AGENDA

Town Planning & Building Committee

Tuesday, 6 November 2018 at 6.30pm

This report considers a planning application for additions and alterations, including a garage and upper storey to the existing grouped dwelling at No. 27A Duke Street, East Fremantle.

DRAWING TITLE			
ELEVATIONS			
JOB NO.	REVISION	DRAWING	
SCALE	SHOWN	305	A.05

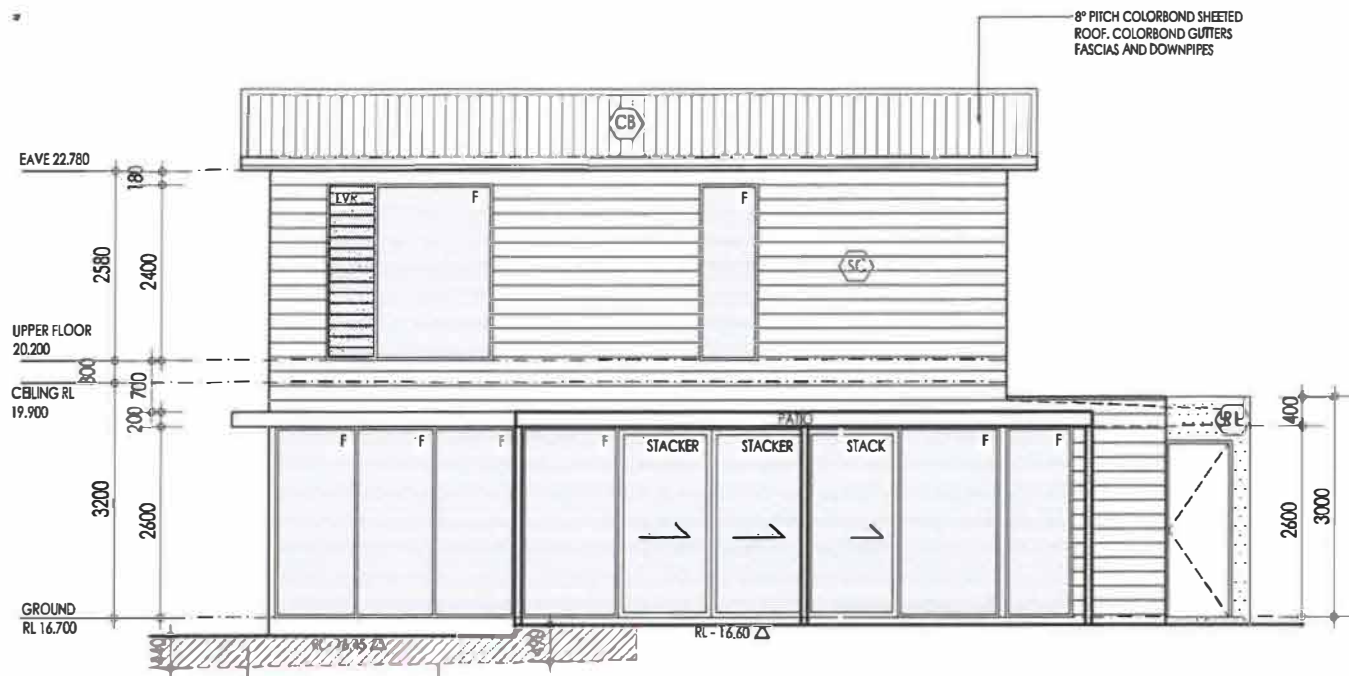
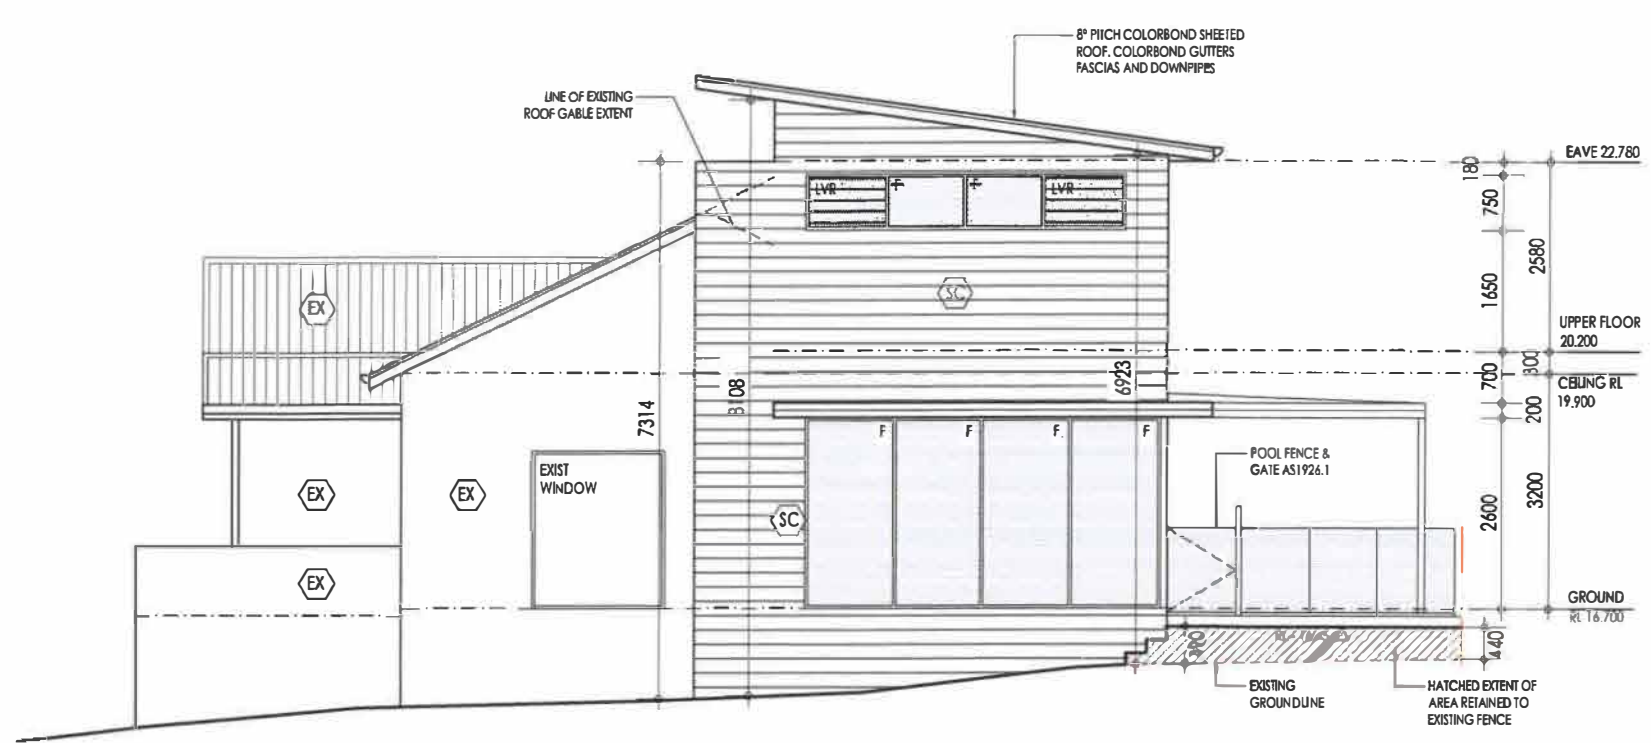
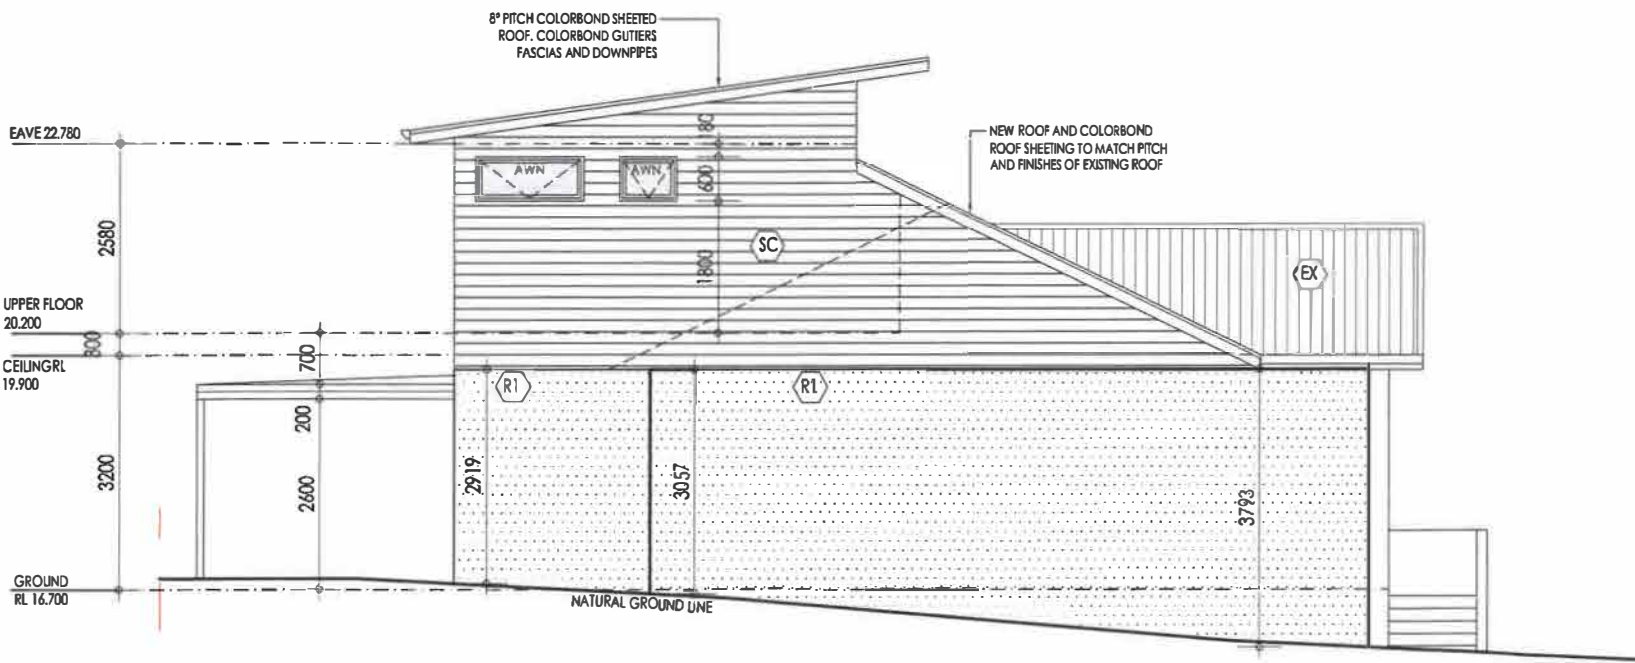
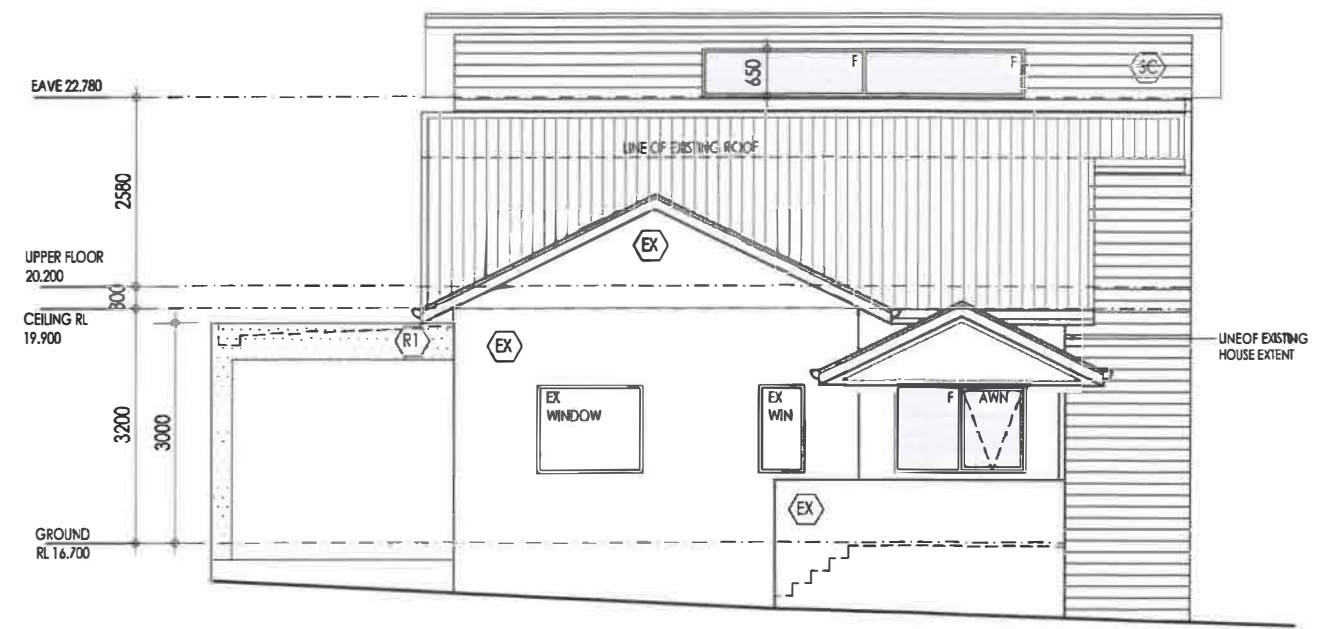
- The Committee consider the design response of the addition overpowers the existing building.
- (b) *The quality of architectural design including its impact upon the heritage significance of the place and its relationship to adjoining development;*

a) *Most of the plan and front elevation of the heritage building is preserved. The new addition is built in the location of a more recent rear extension to the building.*

The site is classified category 'C' under the Municipal Heritage Inventory. With due regard to the CDAC comments the Town's assessment of the proposal supports the applicant's response to the CDAC comments. The heritage frontage is preserved and the new addition is to be constructed in the same location as a more recent rear extension to the residence. The addition is setback 13.5 metres from the
